**Re: 23-45 Tattersall Road, Kings Park – Fire Hydrant Assessment Report Close Out**

# FIRE HYDRANT ASSESSMENT REPORT

## **SELL & PARKER, BLACKTOWN**

45 Tattersall Rd, Kings Park NSW 2148

## 5.1 Fire Hydrant Booster Assembly

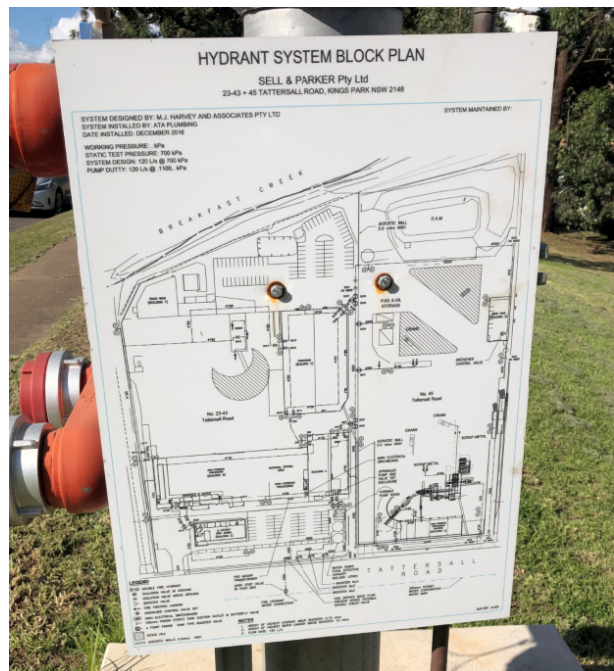
It was observed that the existing booster valves are not secure or locked in the open position.

1. The existing booster assembly is non-compliant due to the booster valves not being secure or locked in the open position.
2. The booster inlet pipes do not have an isolation valves downstream of the booster inlets. Booster inlet pipes are required to have an isolation valve if the head at the inlets can be greater than 50kPa due to the pumps running.
3. No signage to identify the booster assemblies in accordance with Clause 7.10 of AS2419.1 – 2005.
4. FH Block plan has incomplete and incorrect information in accordance with Clause 7.11 of AS2419.1 – 2005
5. The fire brigade hardstand was observed to be non-compliant at the time of inspection due the fire brigade booster assembly being obstructed by parked cars.
6. Boost and Test Pressure signage is not provided for the boosters.

1. The booster valves shall be secured in the open position with a padlock openable by the fire brigade 003 key.
2. Isolation valves shall be provided downstream of the booster inlets.
3. Provide separate stands for signage of

the 'FH Booster' and must be adjacent the suction and inlet points to avoid confusion with the adjacent sprinkler booster.

4. Revise Block plan layout to show the actual configuration of the system including FH30 outside Building B, north arrow, connections for fire monitors, standard of compliance and electrical substation. The location of FH25 adjacent the weighbridge shall be updated on the block plan to reflect the accurate location.
5. The fire brigade hardstand shall not be used as parking. Request council to move no-parking sign beyond booster assembly to keep front of boosters clear at all times.
6. Provide a fade-resistant or engraved sign indicating boost and test pressure in kPa, marked in upper case lettering not less than 25mm in height

Location of FH24

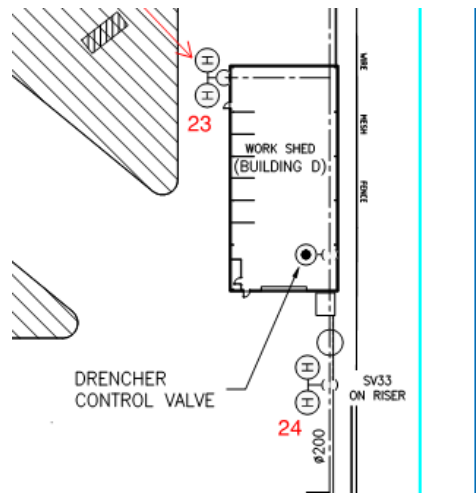
It was observed during the inspection that FH24 was obstructed by existing sheds and did not have a cover.

1. The existing fire hydrant system is not compliant due to the fire hydrant accessibility being obstructed by the existing sheds.
2. The existing fire hydrant system is non-compliant due to the fire hydrant outlet without having a protective cap to block debris and other contaminants from entering the pipes.

1. The fire hydrant shall be relocated to an accessible location in front of the sheds.
2. The fire hydrant shall be kept covered when not in operation. Caps shall be provided to missing fire hydrants.

Risers entering Building B from SV1 and SV2 without bollard protection

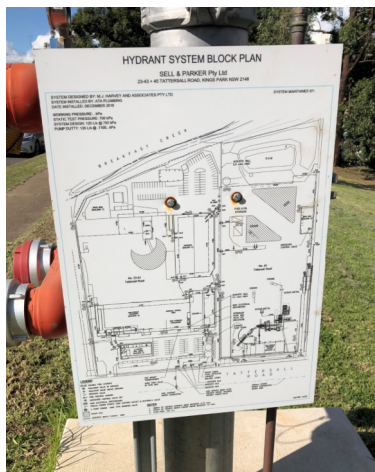
The existing fire hydrant system is non compliant because AS2419.1 requires fire hydrants and pipework to be located so that the fire hydrant system is protected from possible mechanical damage by vehicles. The following pipes are required to, but did not have any protection from physical damage:

- Risers entering Building B from SV19 and SV20
- Risers entering Building B from SV1 and

The risers serving Building B from shall be provided with bollard protection from moving vehicles.

# HYDRANT SYSTEM BLOCK PLAN

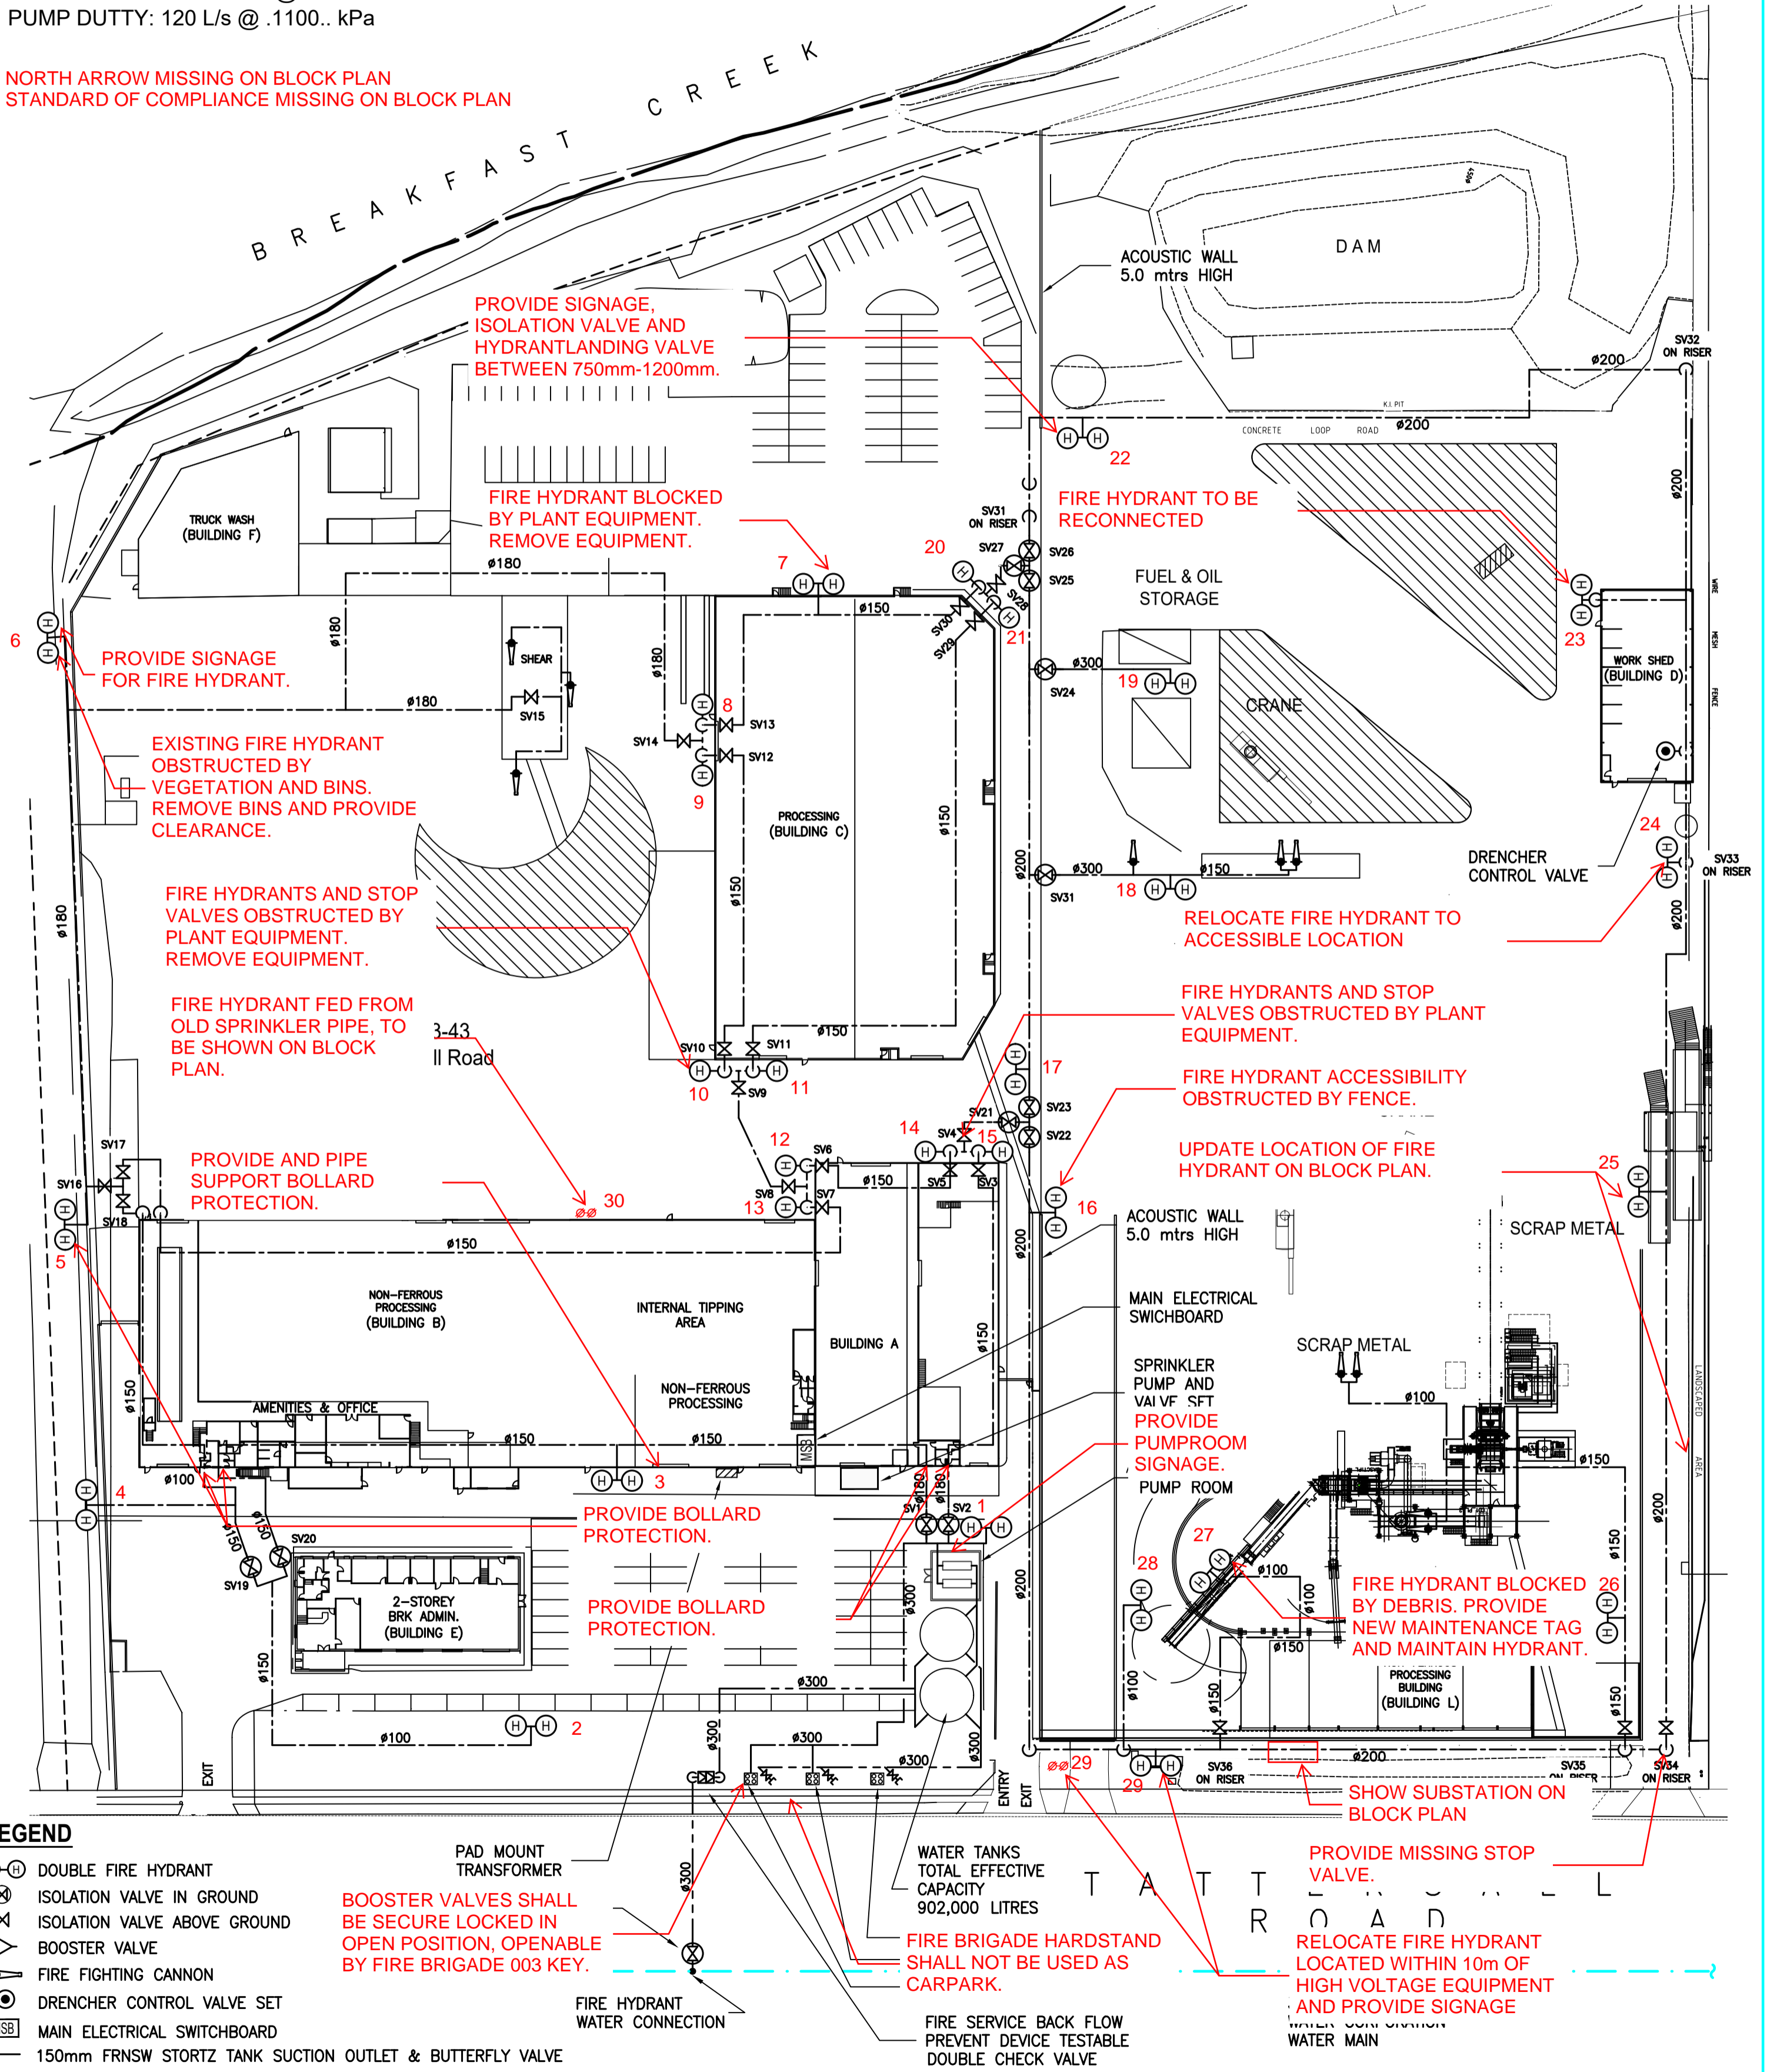
NORTH ARROW MISSING ON BLOCK PLAN  
STANDARD OF COMPLIANCE MISSING ON BLOCK PLAN

BOOSTER VALVES SHALL BE SECURE LOCKED IN OPEN POSITION, OPENABLE BY FIRE BRIGADE 003 KEY.

FIRE BRIGADE HARDSTAND SHALL NOT BE USED AS CARPARK.

PROVIDE MISSING STOP VALVE.

RELOCATE FIRE HYDRANT LOCATED WITHIN 10m OF HIGH VOLTAGE EQUIPMENT AND PROVIDE SIGNAGE
